**MATANUSKA-SUSITNA BOROUGH
PLATTING BOARD
AGENDA**

JULY 7, 2016

**STAFF REVIEW AND RECOMMENDATIONS
PUBLIC HEARING
JULY 7, 2016**

PRELIMINARY PLAT: **ASLS 2015-18**
LEGAL DESCRIPTION: **SEC 28, T19N, R04W, SEWARD MERIDIAN, AK**
PETITIONERS: **MATANUSKA-SUSITNA BOROUGH**
SURVEYOR: **LOUNSBURY & ASSOCIATES**
ACRES: 3.64 ± **PARCELS: 1**
REVIEWED BY: CHERYL SCOTT CASE: 2016-064

CHEYENNE MEADOWS ADDITION 1 DRAINAGE PLAN

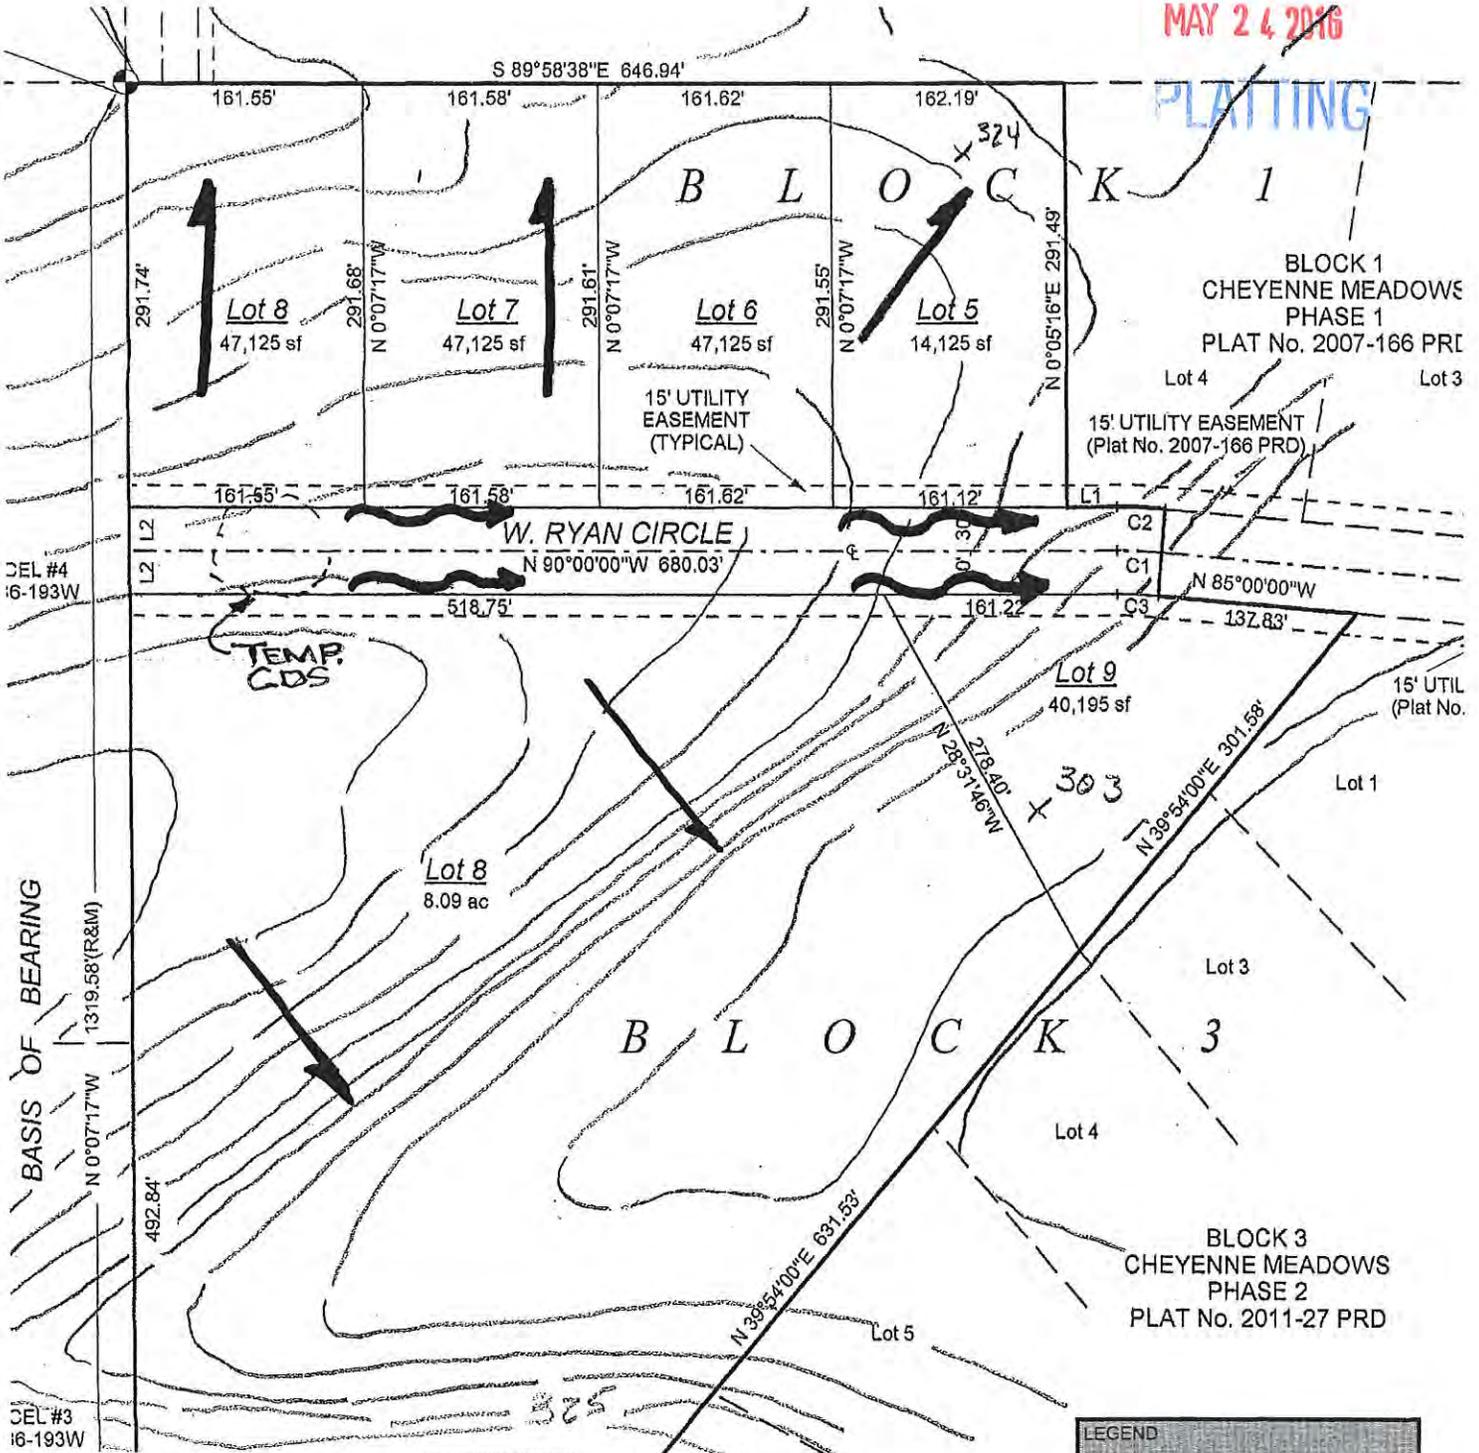
Drainage: Mr. Erdman provided a drainage plan, showing the proposed and natural drainage directions for this proposed subdivision, but did not elaborate in his written report (**Exhibit D**).

Comments: Jamie Taylor, Public Works Engineer, commented that a drainage easement is needed adjacent to the road in the low area in Lot 9 (**Exhibit E**). A cross culvert to direct drainage from the north side of the road to the drainage easement is also needed and the existing temporary cul-de-sac on Ryan Circle needs to be reclaimed. *See recommendations 5 and 6.* She recommends that a condition of approval be placed that requires the developer correct the deficiencies on Morgan Drive to bring it up to residential standards. Staff notes that Morgan Drive was created as a public road the plat of Cheyenne Meadows Phase 2, recorded in 2011. During the one-year warranty period, it was discovered that Morgan Drive and the associated drainage improvements were not up to borough standards, so the road was not accepted for maintenance and a Notice of Deficiencies and Revocation was recorded. Staff notes this proposed subdivision does not rely on Morgan Drive for access, therefore we are not recommending the deficiencies in Morgan Drive be corrected as a condition of approval for this project.

Were you aware of the problems with Cheyenne Meadows Phase 2? DPW revoked acceptance of Morgan Drive due to deficiencies that were never corrected. I recommend that a condition of this next phase be that the developer correct the deficiencies on Morgan Drive to bring it to Borough residential standards.

- Dedicate a drainage easement adjacent to the road in the low area in Lot 9
- Add a cross culvert to direct drainage from north side of road to drainage easement
- Existing temporary cul-de-sac on Ryan to be reclaimed

5. Provide a drainage easement along the road in the low area of Lot 9 and provide a cross culvert to direct drainage from the north side of the road to the drainage easement per MSB DPW Engineer.

AS-BUILT DRAWING OF:
PHASE 1, LOT 1, BIRCHWOOD ESTATES
 A COMMON INTEREST COMMUNITY
 (PLAT RECORDING NO. 2011-55)
 PROPERTY ADDRESS: BRAINARD COURT.
 WASILLA, AK., MAT-SU BOROUGH,
 PALMER RECORDING DIST.

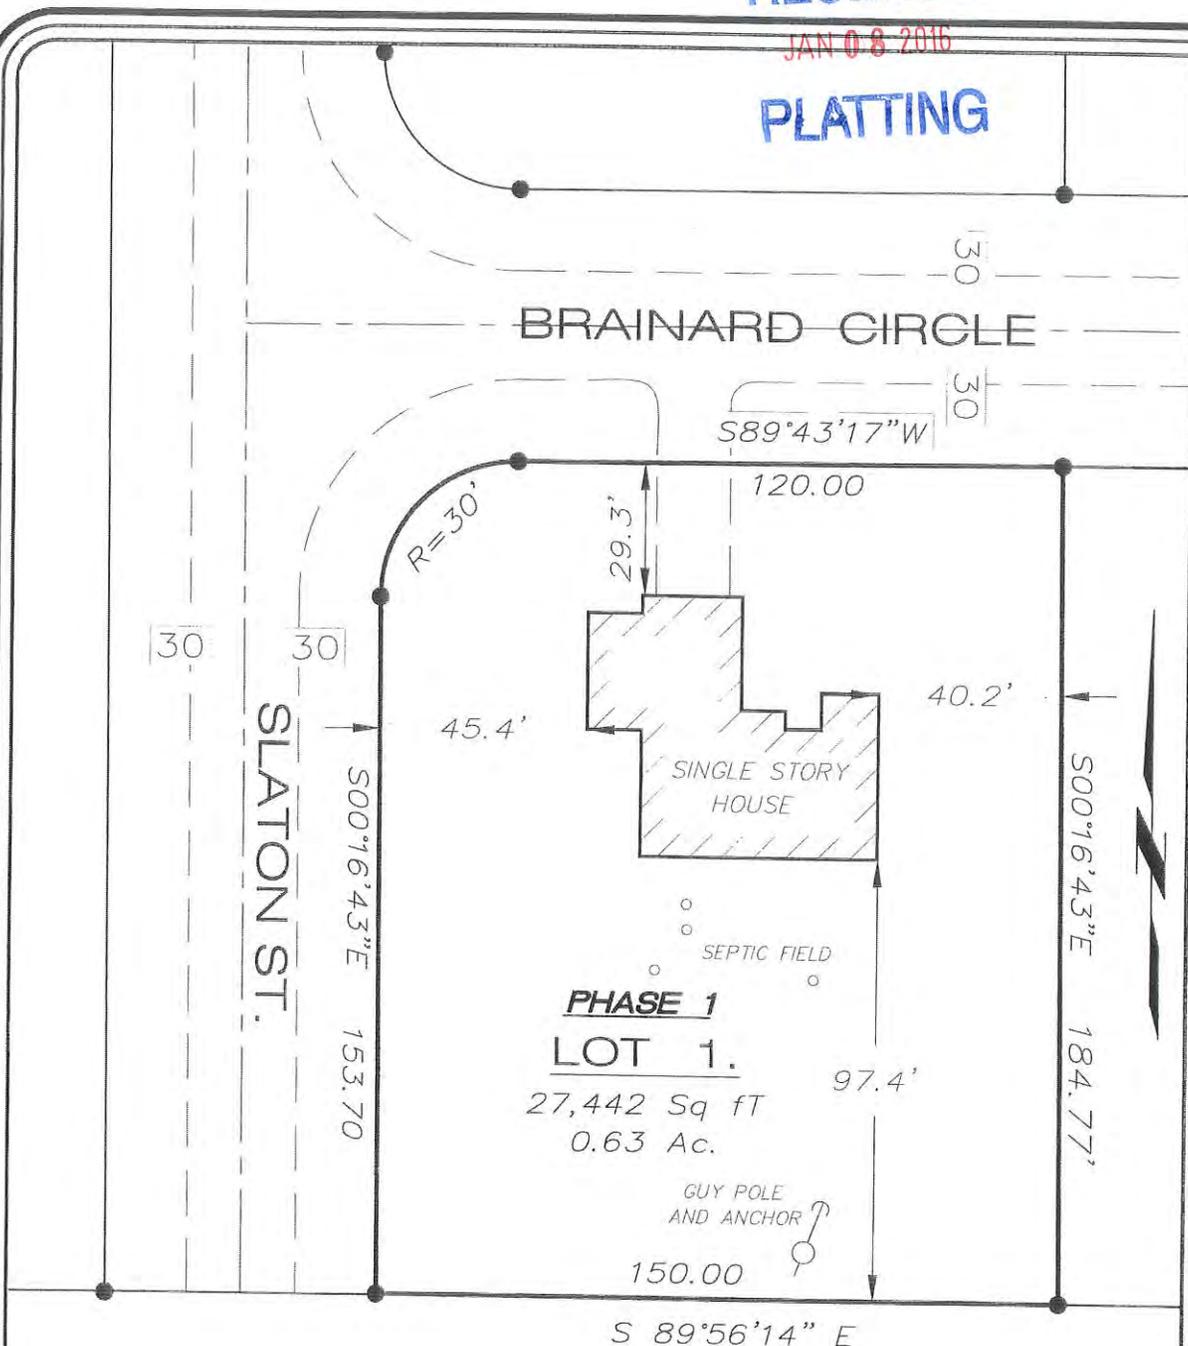
There are buildings on the property, and the developer has designed those so they fall within Lots 7 & 8 and will meet the setback requirements of MSB 17.55. As-builts of those lots provided in January (**Exhibit B**) do not indicate the new lot configuration and will need to be updated. Also the as-built info for the structures on Tract A do not provide the information required in MSB 43.15.016(A)(1)(e). **See recommendation #4**

4. Lot sizes for lots 11, 12, and 13 do not meet the requirements of MSB 43.20.300(A), *Lot and Block Design* for depth vs. width.
5. As-builts provided in January were completed prior to the recent lot design change. Also the as-built information provided within Tract A is not complete. Staff recommends updated as-builts be provided.

3. Redesign the lots to meet the requirements of MSB 43.20.300, Lot and Block Design.
4. Provide updated as-built information to comply with MSB 43.15.016(A)(1)(e) for improvements within the properties involved in this subdivision. Resolve setback violations, if any, prior to plat recordation.

EXHIBIT E - 1

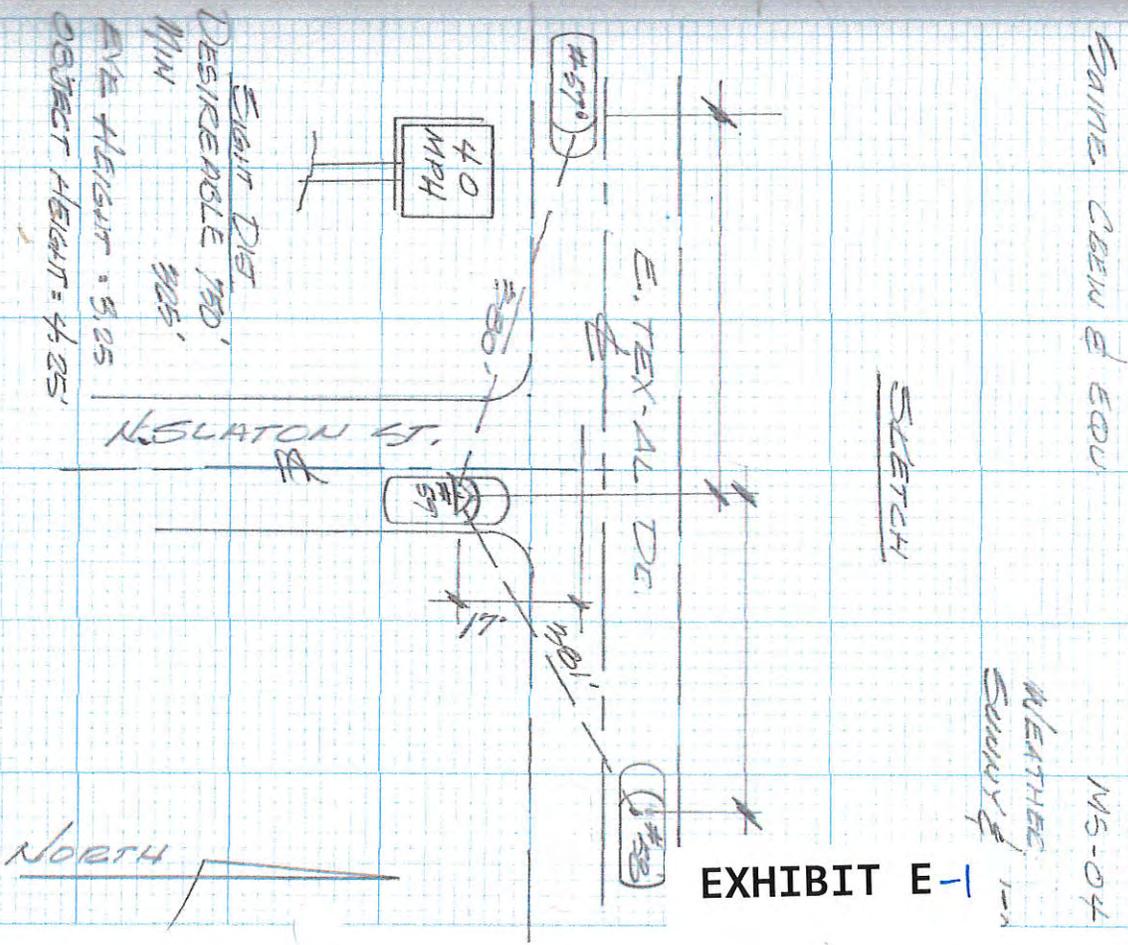
SIGHT DIST
 DESIRABLE 780'
 MIN 705'
 EYE HEIGHT = 5.25
 OBJECT HEIGHT = 4.25'

I showed her your drawing of sight distance and there appears to be some discrepancies. It looks like we're about 100 foot off. Could you help us figure this out?

This is kinda crude, but it is what I was looking for on the sight distance thing. I could analyze it for the best location (a little bit to the east, I think) but that would take a while without having the CAD file. The developer's engineer should do the analysis to determine the best location for the intersection. Let me know if you have any questions.

9. Dedicate 30' curve returns at the intersection N. Slaton Street and E. Tex-Al Drive per SCM A13.2.
10. Provide an engineer's sight distance analysis of Tex-Al Drive to determine the best location for the intersection to maximize the sight distance in both directions. The existing road may need to be moved depending on the results of the analysis. Roads shall be designed to a minimum residential standard per the SCM.

EXHIBIT E-5

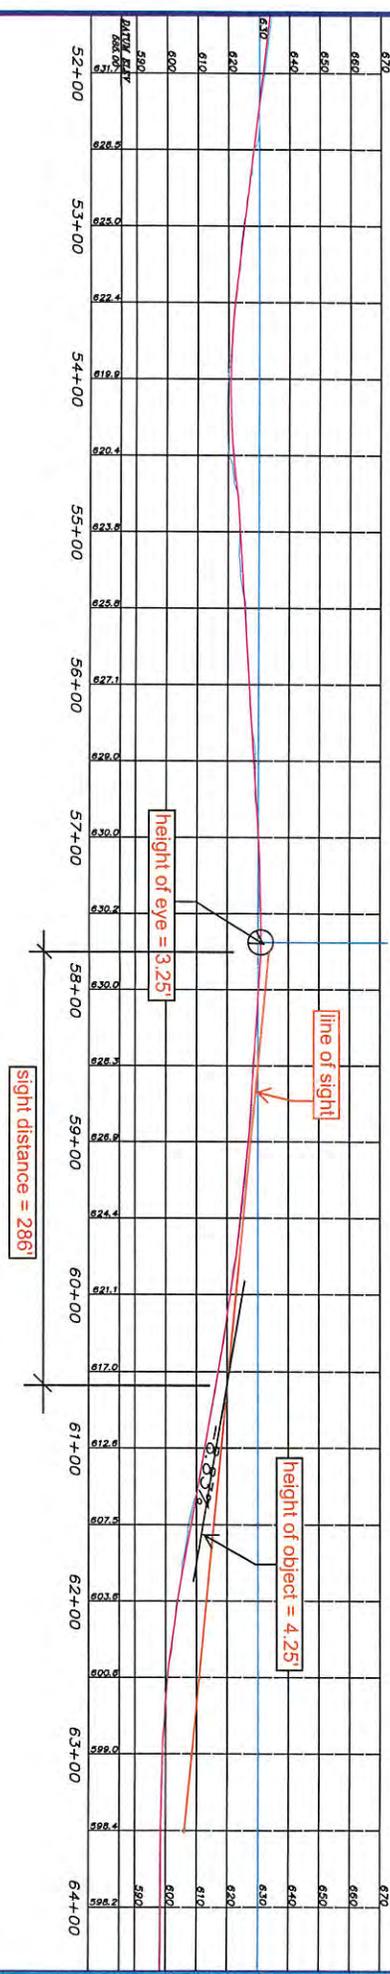
Please note on page 14 of the Borough's Subdivision Construction Manual, specifically the wording of Section A13.1a), second sentence, which reads "*Both intersecting streets shall be designed to provide a minimum corner sight distance as specified in the accompanying chart:*" The chart on the subsequent page then lists various Design Speed/Posted Speed Limits, each accompanied with a Sd (Sight Distance) Desirable and Sd Minimum.

Since the posted speed limit of E Tex-Al Road is 30 MPH, the required sight distance is therefore 200 feet. There is no ambiguity in the wording "shall be designed to provide a minimum". The developers of Birchwood Estates have not only done that, but actually improved upon it by achieving a sight distance of 312.74', exceeding the minimum sight distance of 200' by almost 64%.
